Re: Minor Project Refinement No. 18 for the TL 6975 San Marcos to Escondido Project

TL6975 San Marcos to Escondido 69 kV Project CPUC Minor Project Refinement Form

**TL6975 SAN MARCOS
to ESCONDIDO PROJECT**
MPR-18
Location 4 Additional Work Area
San Diego County, CA

ATTACHMENT B
MPR-18 Figure

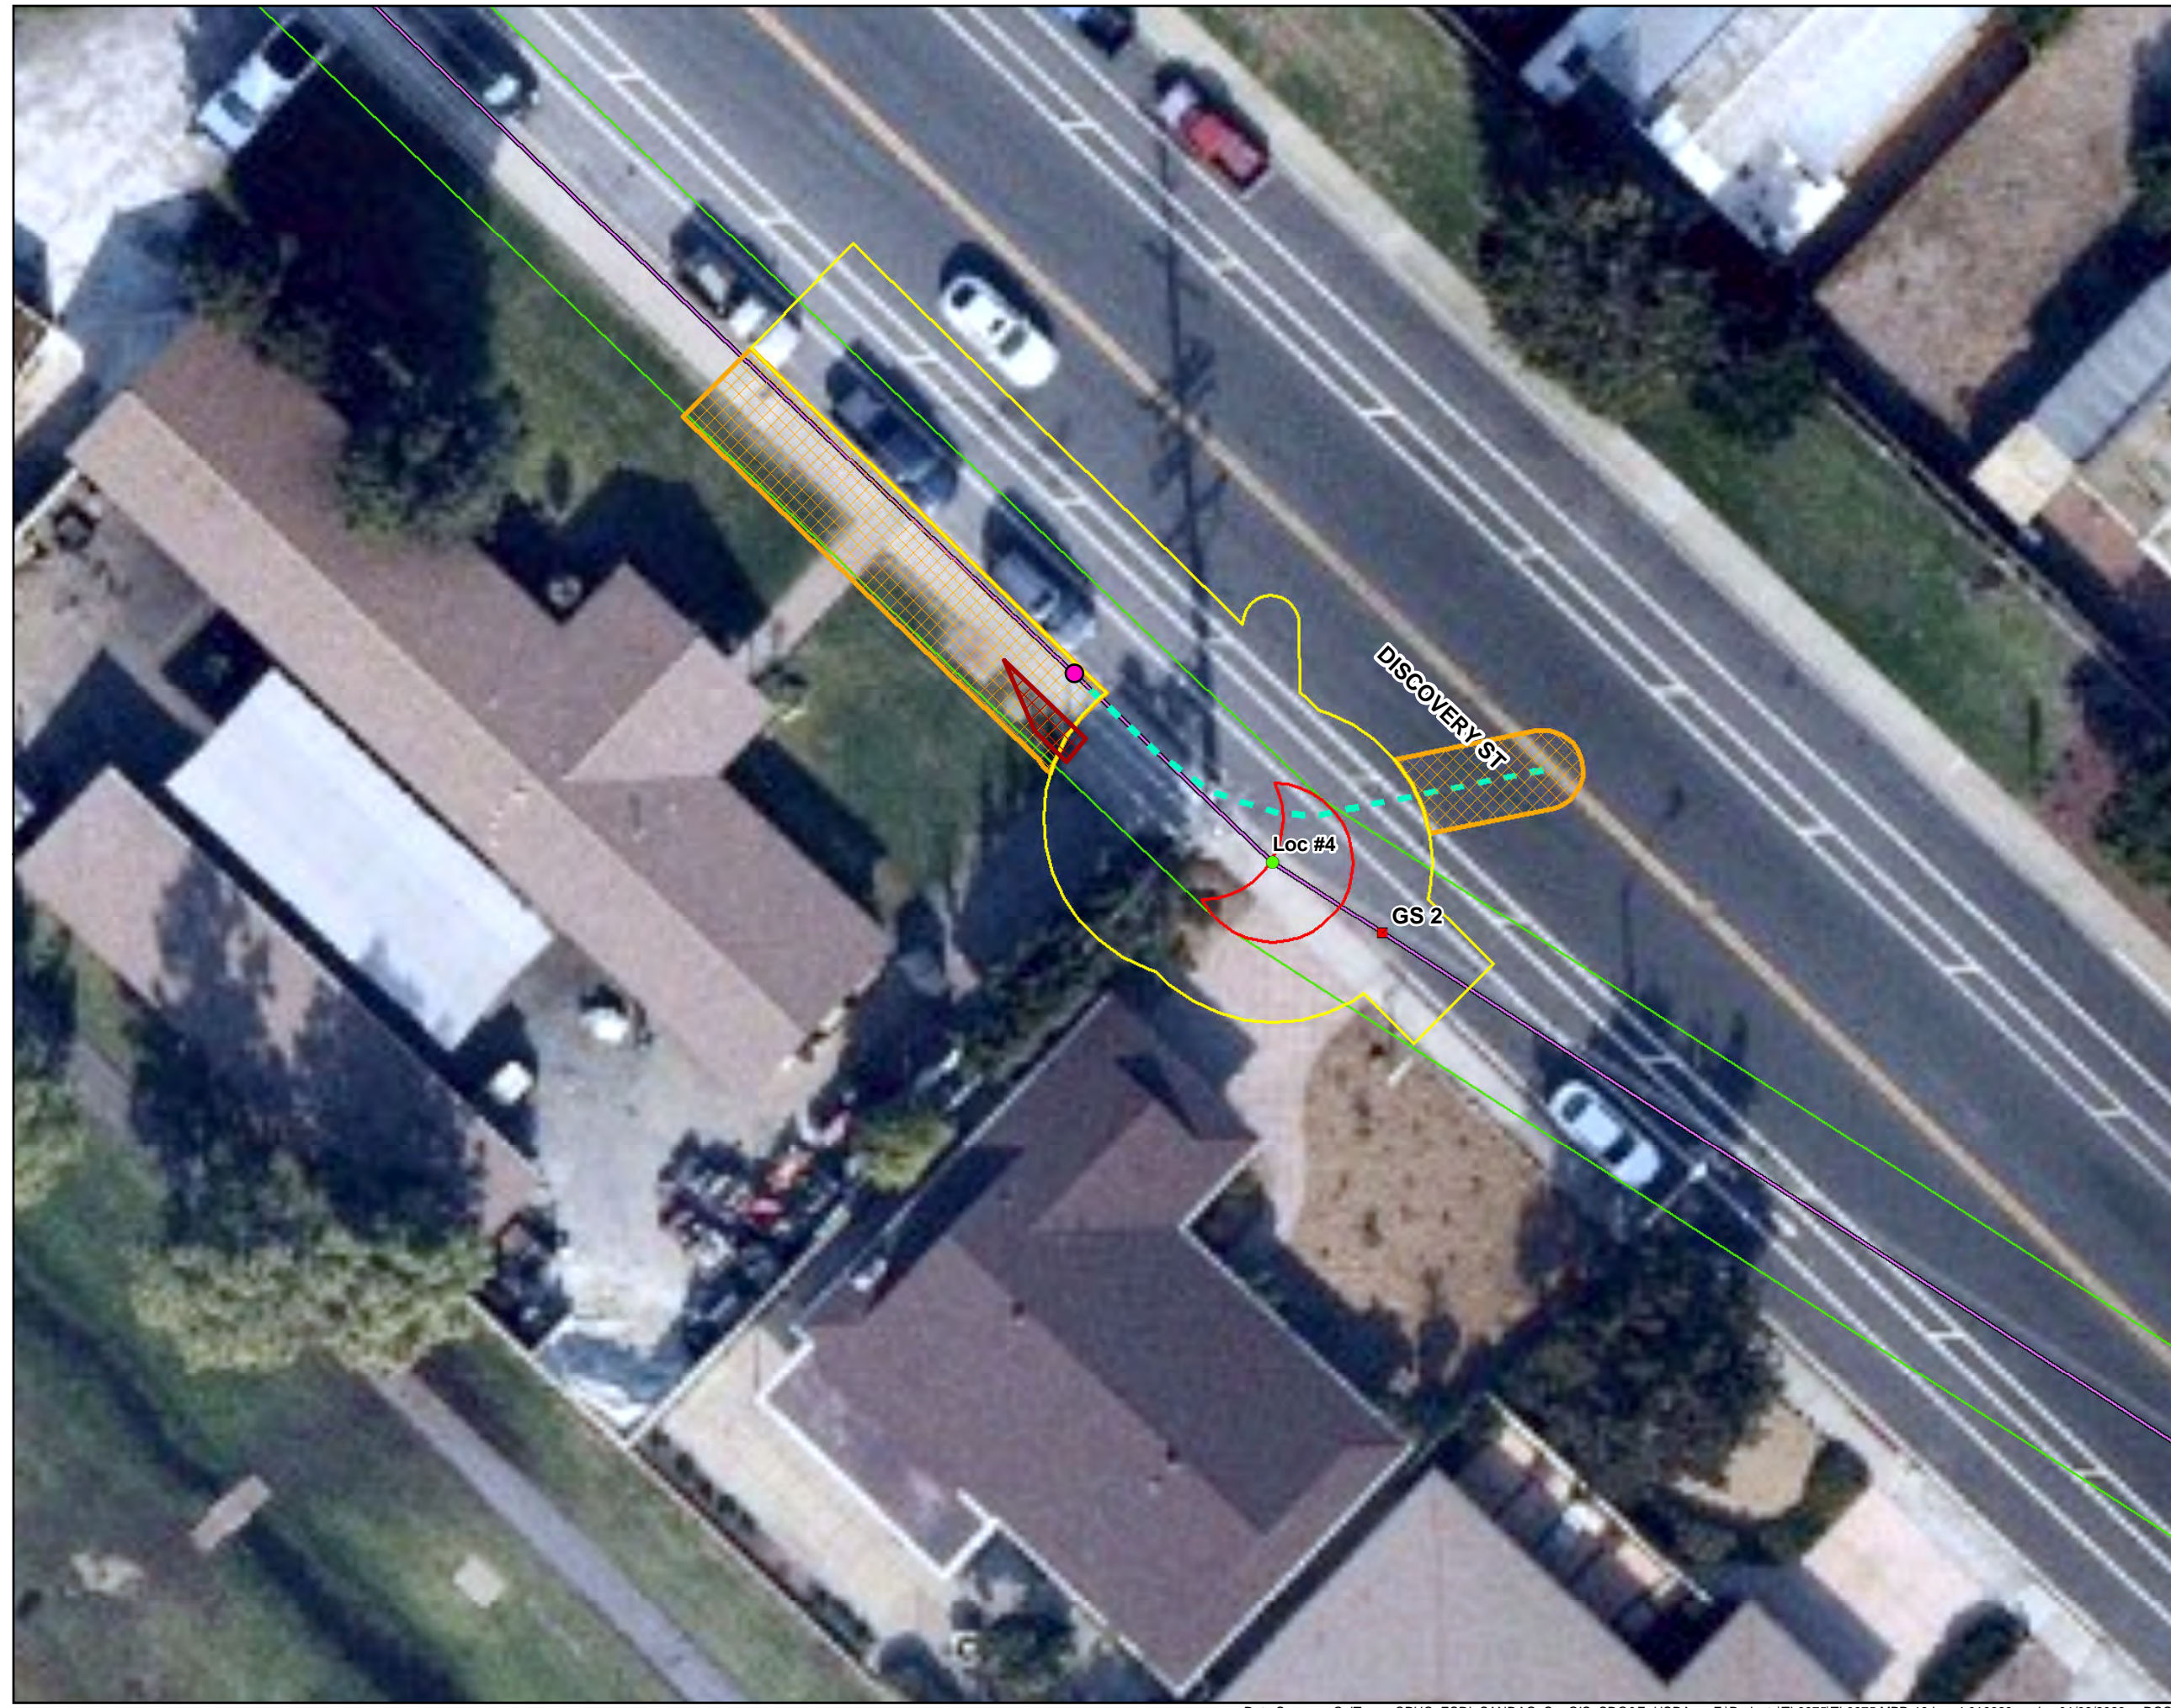
- **Location 4 Proposed Modifications:** The new pole at Location 4 will be installed approximately 25 feet northwest of the original location shown in NTP-1 and IS/MND mapping. An additional 35 square-foot permanent work area will be required at Location 4, where the existing sidewalk will be extended within County of San Diego ROW. An additional

1,090 square-foot temporary work area will be required at this location to complete the pole installation, sidewalk extension, and underground distribution tie-in work. Trenching will be required in order to intercept and reroute the distribution conduit to the new pole at Location 4 (see **Attachment B**). Most of the underground work will take place within the previously approved work area for Location 4. The ornamental grass within the permanent portion of the work area will be removed.

As an alternative, it is being proposed in this MPR-18 request that Location 4 be moved 25 feet northwest. This location would allow enough space for the wet hole direct-bury pole installation and would avoid the need for the multiple day outage that would be required for a same-hole set. As a result of the movement of Location 4, the existing sidewalk must be extended in order to allow pedestrian flow around the new pole sites, and to meet ADA sidewalk clearance requirements. In addition, underground trenching will take place in order to intercept and reroute the underground conduit.

Photograph 1:

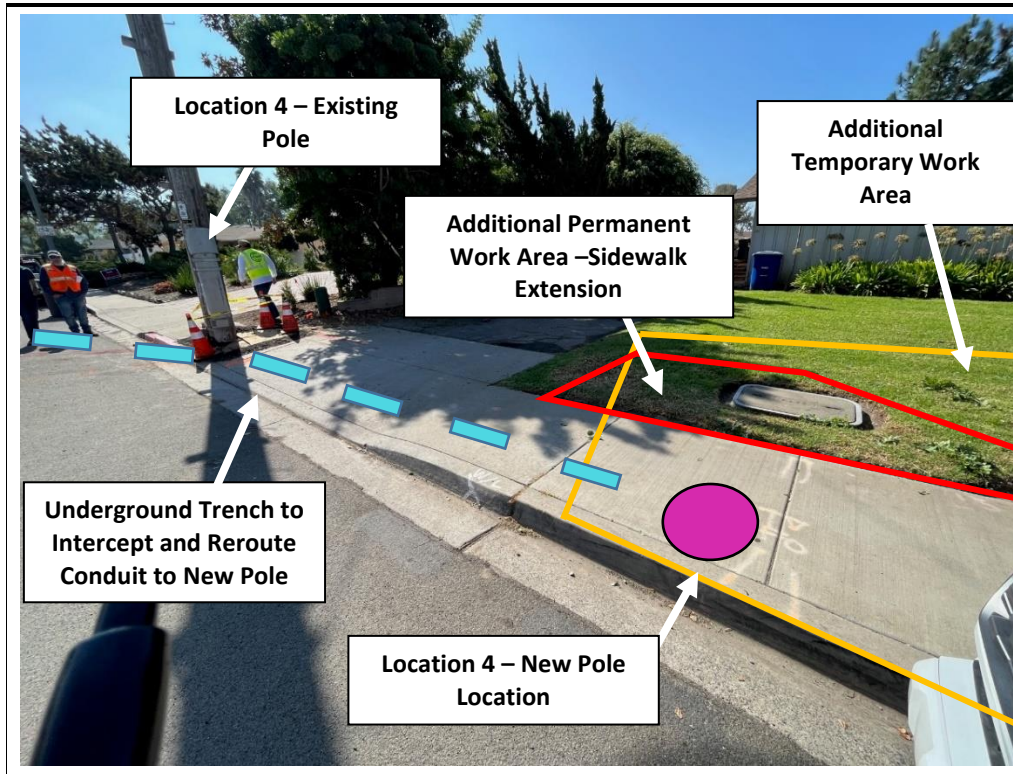
View of the existing and new Location 4 pole sites and the additional work area required for the new pole installation and sidewalk extension. Facing: South

Photograph 2:

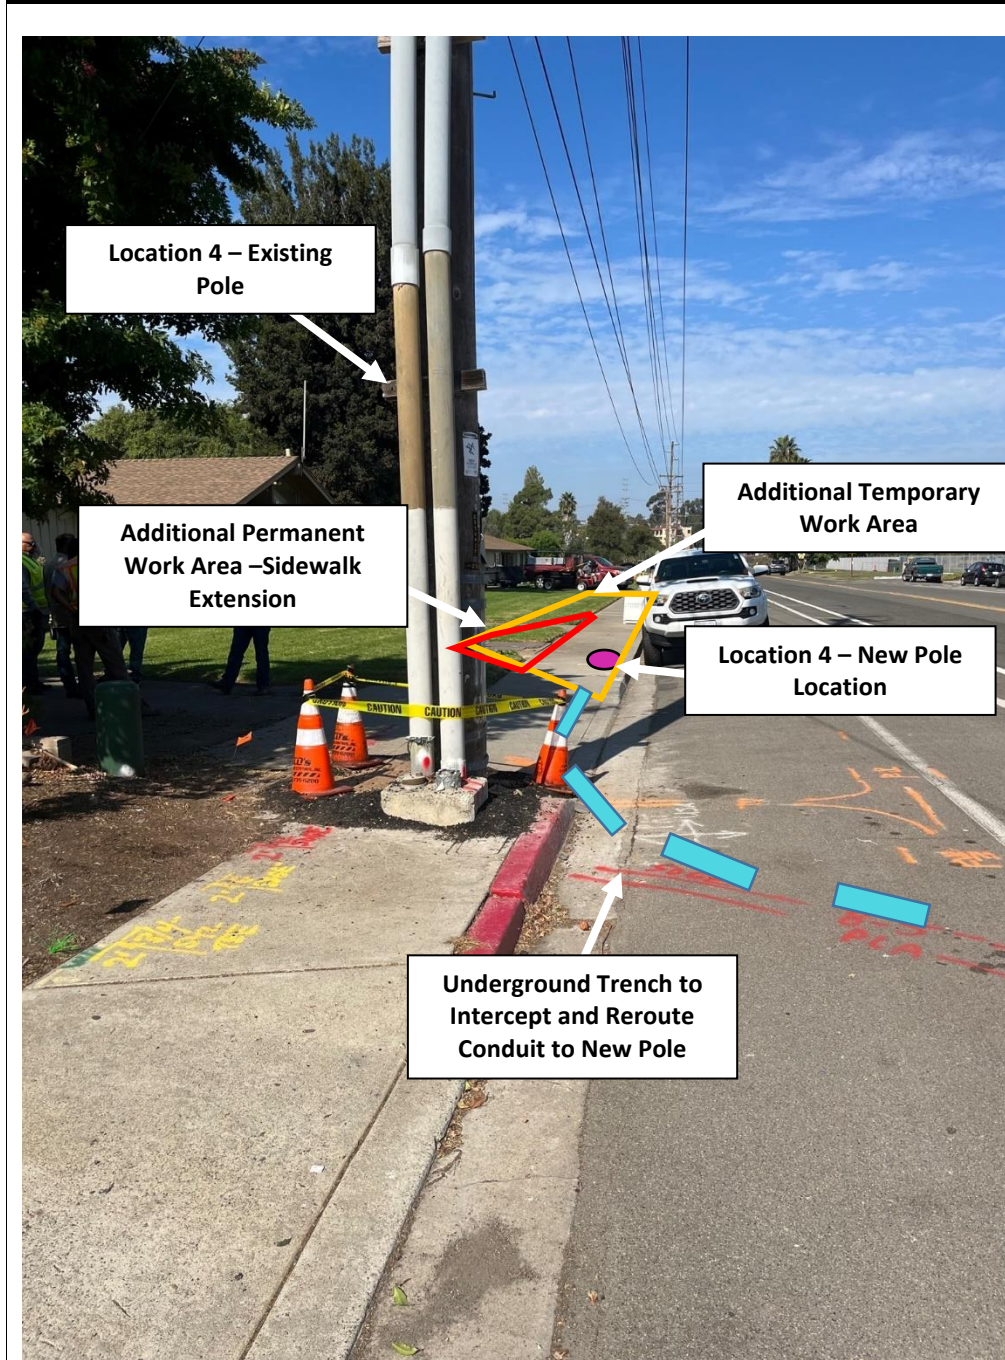
View of the existing and new Location 4 pole sites and the additional work area required for the new pole installation and sidewalk extension.

Photograph 3:

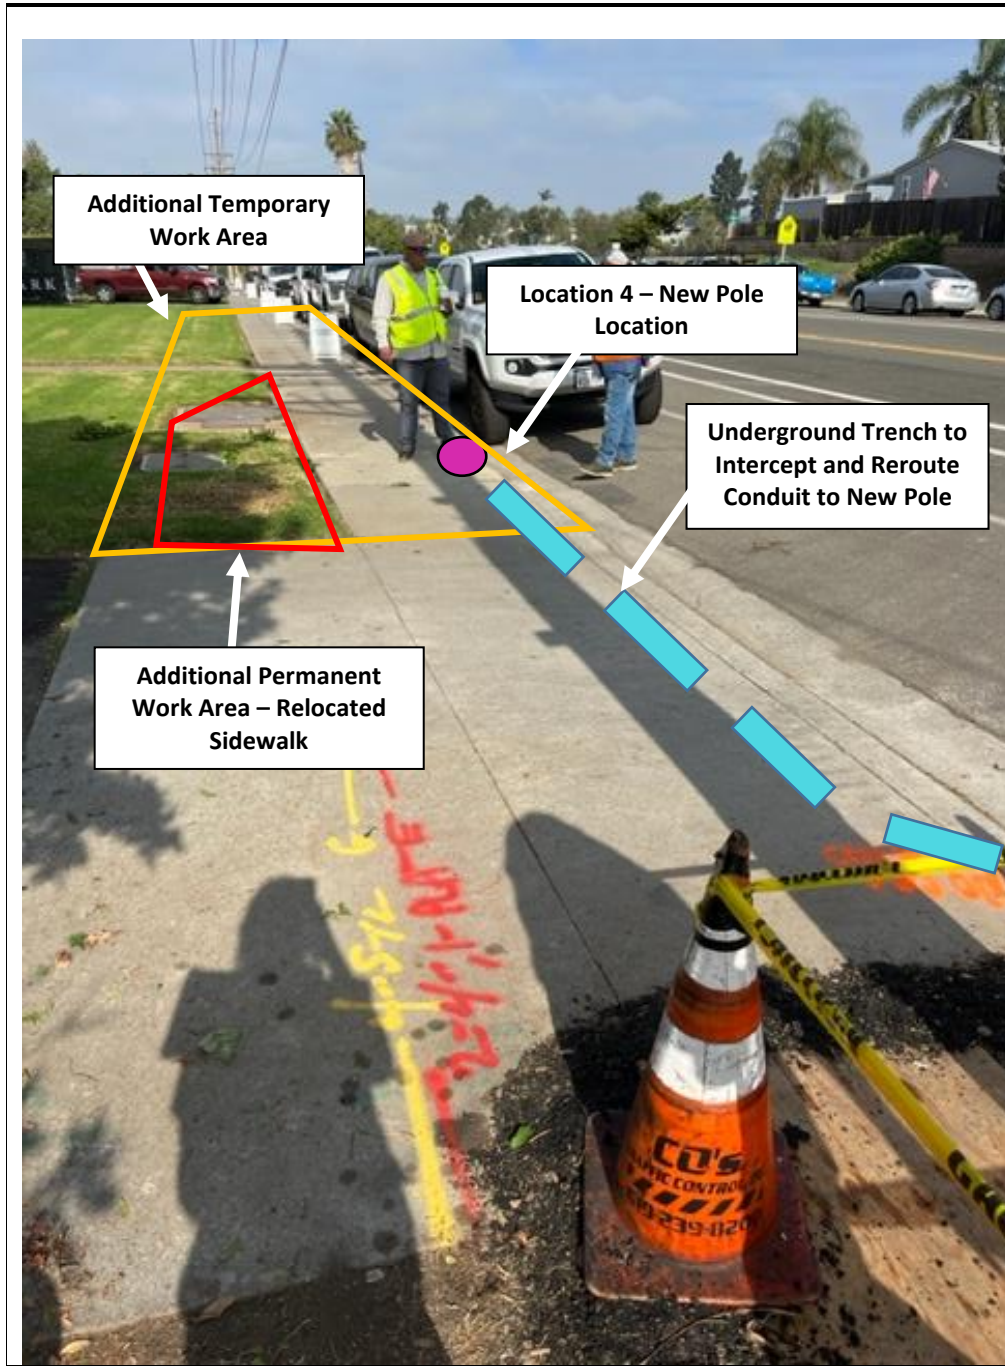
View of the existing and new Location 4 pole sites and the additional work area required for the new pole installation and sidewalk extension. Facing: North
